Application Number:	AWDM/0873/24	Recommendation - APPROVE, subject to consultation response
Site:	Land East Of 1 To 11 Mercury House, Ham Road Shoreham-by-Sea, West Sussex	
Proposal:	<p>Application to Vary Condition 27 of previously approved AWDM/1024/23 and AWDM/1450/21.</p> <p>Amendment comprising: Alternative landscape design, including use of containers for planting along site frontages (in order to accomodate underground drainage attenuation tanks), also provision of electricity substation within central courtyard, with associated changes to landscaping.</p> <p>Original description (as previously amended by AWDM/1024/23) : erection of two blocks of development ranging in height between 3 - 9 storeys comprising 159 residential units comprising a mix of 1-bed, 2- bed and 3-bed units (including a minimum of 30% of affordable housing), commercial (class e) floorspace at ground floor, and associated parking and landscaping. Application to vary conditions 1 of previously approved AWDM/1450/21</p>

Applicant:	The Hyde Group	Ward: St. Mary's
Agent:	HGP Architects	
Case Officer:	Stephen Cantwell

Proposed Layout - to show sub-station (circled in centre) and trees (circled at perimeter)

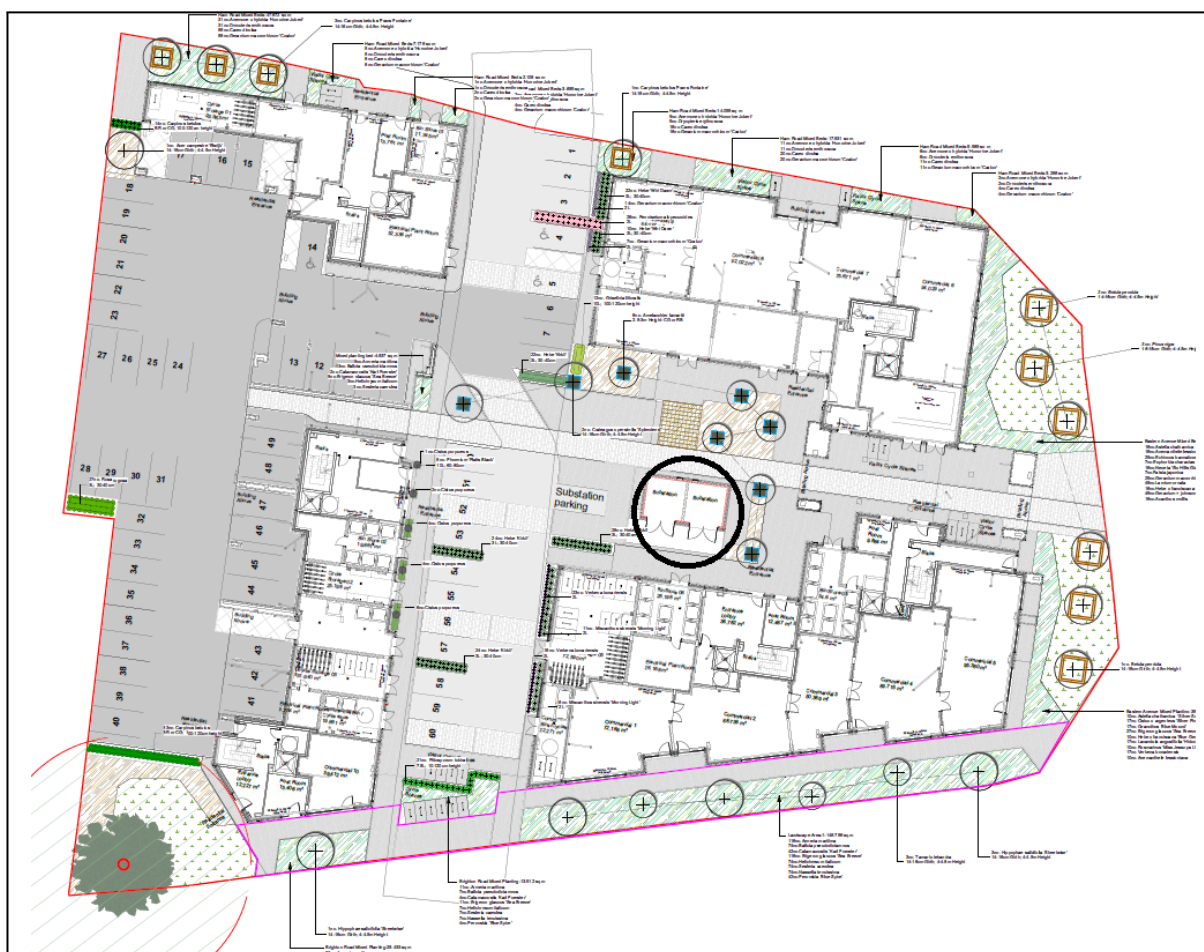
This application, recently amended (21st August), seeks variation of approved drawings, including the landscaping requirements of condition 27, in order to include an electricity substation in the internal courtyard also to containerise new tree planting at the site frontage.

The recent amendment now limits the containerisation of trees to the Eastern Avenue frontage. Planting along Brighton Road would be direct into the ground, as previously approved.

'Landscaping: AREA endorse the changes to the chosen landscaping although it is disappointing that all planting must now be in containers, which will restrict the growth of the trees. This will also involve additional upkeep and attention. Can it be confirmed that at no point will the cost of the maintenance of the landscaping be passed on to the residents?

We ask that the planting of 3 pinus nigra trees be reconsidered. According to the RHS these trees grow 20-55 m high and the spread is 6-12 m. So, unless the landscapers have found a dwarf variety; this option is too large for containers. The RHS suggests sophora microphylla as a good evergreen choice for containers, height 10 m, spread 6m.

Courtyard Layout Images: Proposed (upper); Approved (lower)

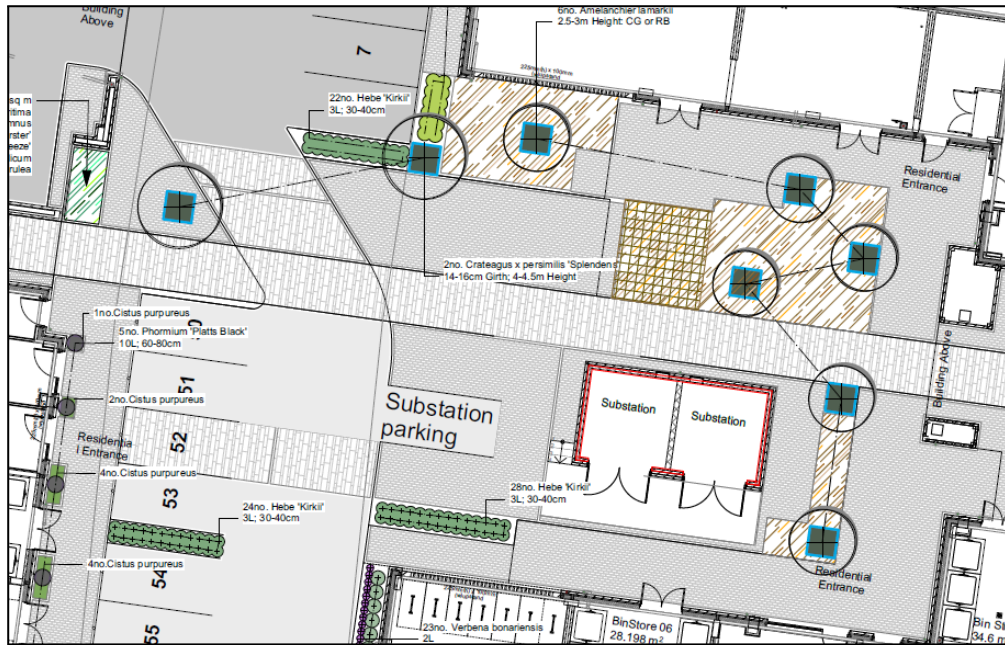
Substation: Why has it taken so long for the developer to include electric substations? Have they only just realised that they need them? AREA object to this amendment. The courtyard where Hyde proposes to locate the substation, is the only outdoor area with seating and a small area for children to play. By locating the

substations there, they have considerably reduced the space for seating and play.

In terms of location and design, the proposed substation is located at the southern side of the courtyard as a single storey building. This would use facing bricks to match those of the approved Block B. The proposed layout plan above (upper image) shows landscape planting as buff-coloured hatching and green shading. The buff-coloured grid is a grass-crete-type pavior area, planted with wildflower turf. Trees are shown in containers edged in blue.

The lower of these images is the approved plan, including an area of planting to the southern side, much of which would be removed in the proposal.

As can be seen in the two images the planted areas of landscaping have reduced, including the reduction of trees from ten to eight, in order to provide access to substation parking (one has also been removed in order to provide for fire tender access, which has already been approved as part of fire safety details). Trees are also in containers, as explained in the next section of this report. Informal drifts of varied hard surfacing and boulders and benches are also no longer in evidence.

The combined effect of these changes is to reduce opportunities for informal recreation and visual amenity and to an extent, its biodiversity value. In order to mitigate this impact the applicant has been asked to consider whether the following are possible:

- 1) Amalgamation of the fire tender and sub-station service vehicle spaces, in order to allow more of the approved planting to be retained
- 2) Reintroduction of informal play opportunities and benches
- 3) Vertical landscaping, such as frames, logias or wires, to support climbing plants
- 4) Biodiversity value of the resulting amended plan to be described, including any measures which may enhance this (such as bird boxes and biodiverse planting)

Amended Plan - Tree Planting in-ground Brighton Road, others containerised.

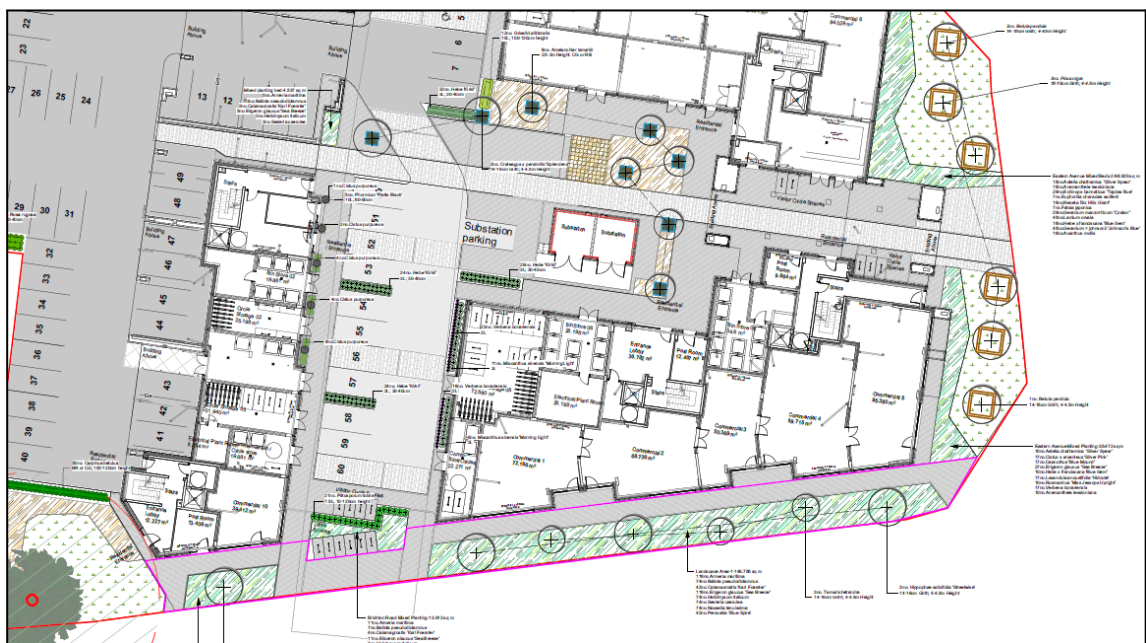
As submitted, the application raised concerns that this containerisation would disrupt the pattern of new planting along the north side of Brighton Road. This includes existing trees and new ones to be planted at the southern side of The Ham recreation ground to the east and the now-retained poplar tree at the south west corner of the site frontage. This frontage is also within the setting of the conservation area and listed buildings further west along New Road.

Comments of the highway and drainage authorities and tree officer are awaited on this change, partly to ensure that this planting remains consistent with plans to realign the road edge as part of the future cycle path for Brighton Road. It is also to ensure that the manner of planting safeguards main drains, for instance this may require the installation of a root barrier in the ground.

The two tree varieties for Brighton Road Buckthorn and Tamerix are as previously agreed and are shown above. Trees at the Eastern Avenue frontage would be containerised, these are a mixture of birch and pine. It is noted that comments by AREA recommend against the use of pine here. The tree officer's comments on this are awaited.

In response, a review of drainage arrangements has led to a recent amended plan (below). This now leaves roadside planting in the ground along Brighton Road, so that this would now be consistent with the Ham and the existing poplar. Other shrub and herbaceous plating is also shown alongside Brighton Road. This assists in amenity and biodiversity value
